UNITED STATES PATENT AND TRADEMARK OFFICE

APPLICATION NO.	FILING DATE	FIRST NAMED INVENTOR	ATTORNEY DOCKET NO.	CONFIRMATION NO.
10/030,595	01/08/2002	Robert W. Tritchler	GRC 19.329 (100671-00050)	6456
26304	7590	11/19/2003	EXAMINER	
KATTEN MUCHIN ZAVIS ROSENMAN 575 MADISON AVENUE NEW YORK, NY 10022-2585			DUNWOODY, AARON M	
			ART UNIT	PAPER NUMBER
			3679

Office Action Summary	Application No.	Applicant(s)
	10/030,595	TRITCHLER ET AL.
	Examiner Aaron M Dunwoody	Art Unit 3679

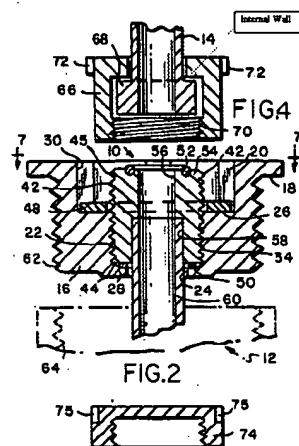
Claims 14-18 and 21 are rejected under 35 U.S.C. 102(b) as being anticipated by US patent 4927188, Sands.

In regards to claim 14, Bedecker discloses a swivel joint for connecting to a water line in a plumbing accessory outlet, the joint comprising:

a first element (14) having a barrel with an externally projecting milled face, and
a second element (10) having a barrel with an externally projected milled face,

wherein a resiliently deformable sealing member (52) is accommodated in one of the faces, and the first and second elements are held together in face-to-face relatively rotatable relationship by means of a cylindrically shaped housing;

wherein the cylindrically shaped housing is rotatably engaged with one member and receives the milled barrel of the outer member within the housing and is adjustably engage with the other member whereby adjustment of the collar enables the tightening of the swivel joint.

In regards to claim 21, Bedeker discloses the housing including an internal wall (see Figure 2 below), offset from one end of the housing, with an opening therethrough.
